July 9, 2021

*To: John Hansman, MIT
% Flavio Leo, Massport
and David Carlon, CAC*

*From: Thomas Dougherty
MCAC member, Milton*

2. Reiteration of Requests for Analyses and Presentation of Overflight Dispersion via One or More Alternative, Rotated 4R Arrival Paths

**RealContours™ Air Carrier Arrival Tracks
(October 2009)**

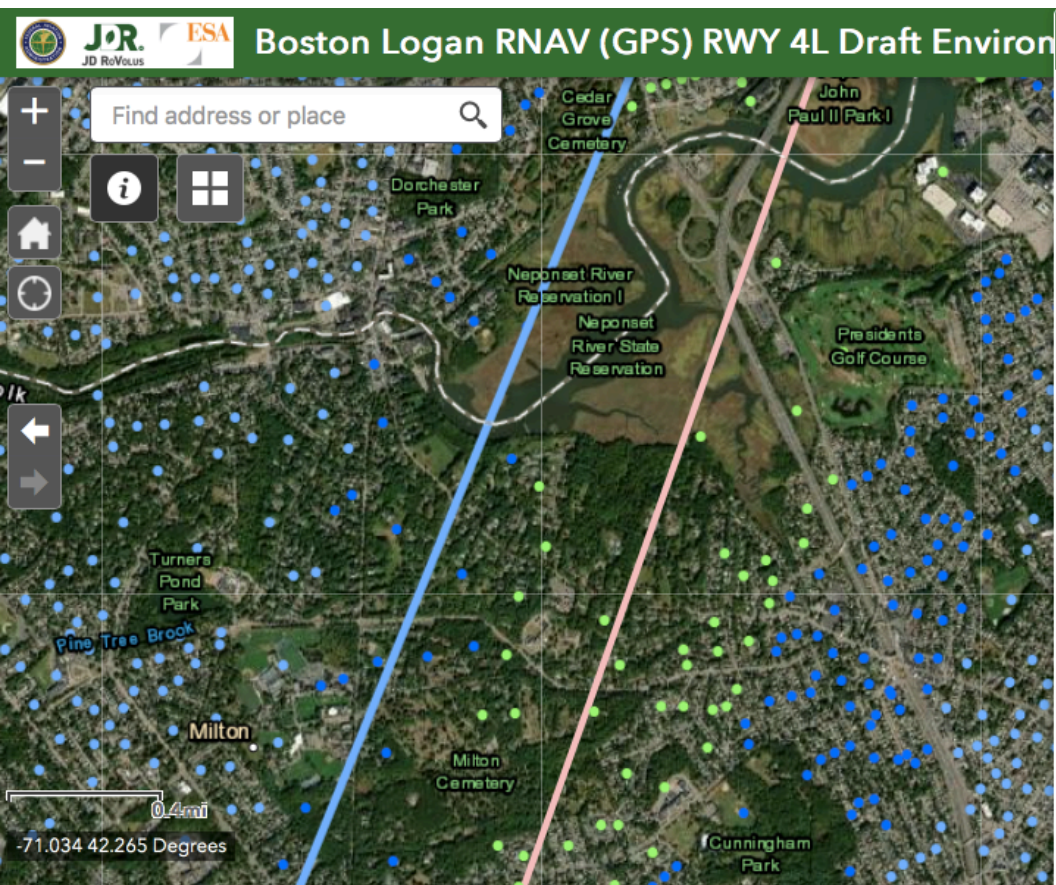
We have pointed out that the slides used in the MIT June 24 Report to illustrate the pre-RNAV 4R arrival flight tracks are imaged at much too far-removed a height to fully

depict the pre-RNAV baseline reality. We previously provided the following slide to the MIT team, and present it here. It was developed at our request by Massport using RealContours Air Carrier Arrival Tracks for October 2009 drawing upon the three Massachusetts Agency sources stated in the slide.

It vividly shows the pre-RNAV flight tracks to the east of Milton over much of Quincy that were collapsed into the RNAV sky-rail over Milton.

Massports' EDR for 2015 itself shows that 78% of Quincy census blocks had a decrease in noise between 2009 and 2015 despite increases in the number of overflights, while 60% of Milton census blocks experienced noise increase.

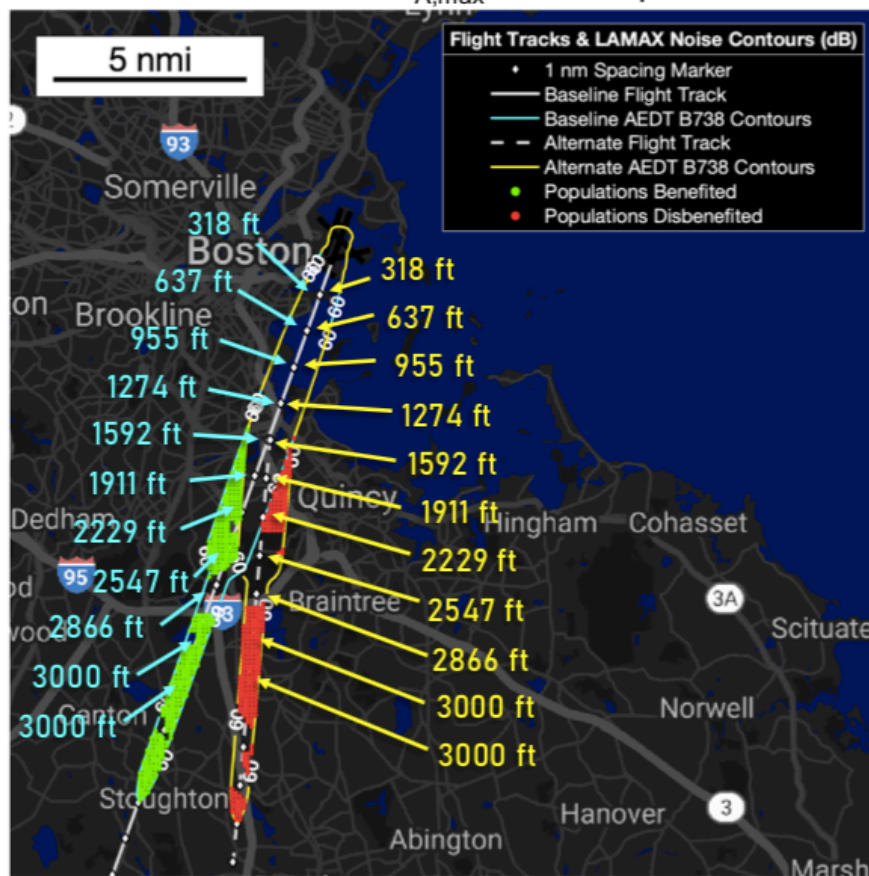
Next, we asked MIT to include the FAA's own slide of the location of the 4R (and proposed 4L) RNAV approach paths, which we asked FAA to prepare in connection with its pending Runway 4L Environmental Assessment. Because it was not included in MIT's presentation, we renew that request and present it here. It vividly shows the narrow 4R sky-rail concentrated over Milton, well to the west of even West Quincy.

4R RNAV Approach 15° Final Approach Intercept

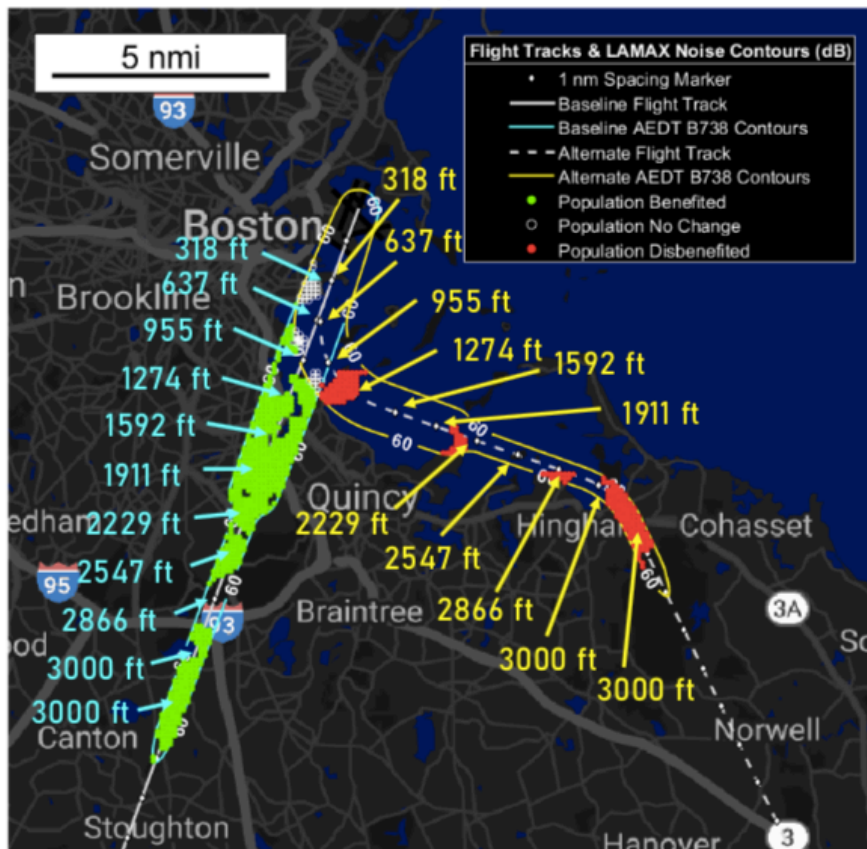
We requested a JetBlue mirrored path, given that its 15-degree intercept would likely be practicable because the JetBlue 4L path was analogous. MIT's comment is that for this path to merge with the existing 4R RNAV path there could be technical difficulties. We are not at all aeronautics experts. But that is not the procedure we asked be analyzed in our follow-up to the April General Meeting. Instead, this RNAV 15-degree Final Approach Intercept should be analyzed as an alternative path used in rotation with the extant RNAV 4R path—not as a path merging into it during a concurrent use mode. Rather, this path is flyable and could be used in rotation with the extant 4R path to provide dispersion over a course of days or weeks by use of the extant 4R RNAV on some days, and this 4R 15-Degree Final Approach Intercept path on other days.

The frequency of rotation could be tested and measured so that the residents under the extant path receive a proportion of flights that takes into account the 5892 higher resident exposure when the 15-degree final approach intercept path is in use. Equal balancing could put that at 14.4% higher—not 100% higher as the present single 4R RNAV imposes on its underlying residents.

That percentage is to be determined. This Study needs to include such analyses to facilitate its determination.

MIT's RNP Minimal Population from the South (Figure 19)

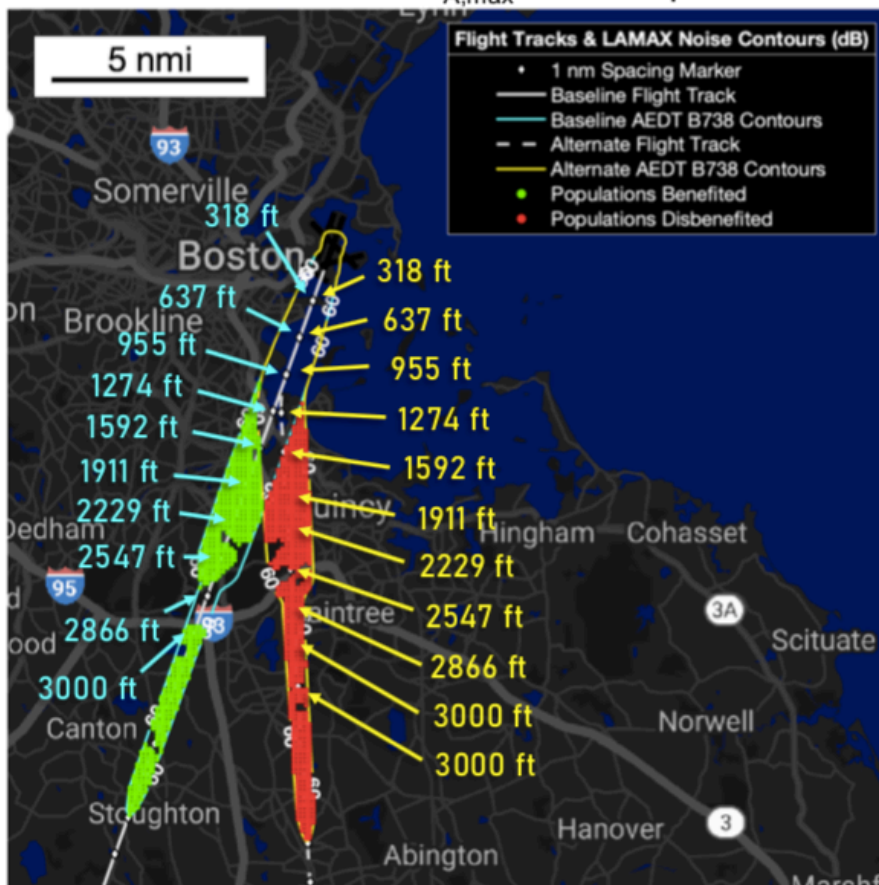
Again, for each of those procedures, we asked that they be evaluated as complementary to the existing 4R RNAV to be used concurrently with the existing RNAV not in substitution for it. That would disperse overflight burdens.

MIT preliminarily reported in July 2020 that there are concerns about merging and sequencing aircraft on modeled 4R RNP with the existing RNAV. We asked, and we ask again, that MIT address the existing precedents at Reagan National, Atlanta, Chicago, Houston and other airports to show what the percentage of RNAV to RNP use is, what the rotation process is, at what nautical mile from touchdown merging occurs, and what the safety experience is.

To address the merger question, we also asked that MIT consider how the 2017 FAA approved use of a side-step procedure onto 4L for aircraft arriving on the 4R RNAV path during 4R runway reconstruction could be used, if necessary to address merging and sequencing of the RNP paths with the 4R RNAV. In 2017, the side-step was used safely on 4R approaches and stated by FAA to be "a typical procedure used at airports throughout the National Airspace System (NAS) that provides both air traffic controllers and pilots an additional option in landing aircraft (FAA CATEX Announcement March 2017)

A side-step would also allow RNP planes to stabilize earlier. MIT's Figure 19 shows 955 foot altitude near 3 nautical miles from the airport (1000 feet and 3NM being the norm stated by MIT). So that procedure should be modeled.
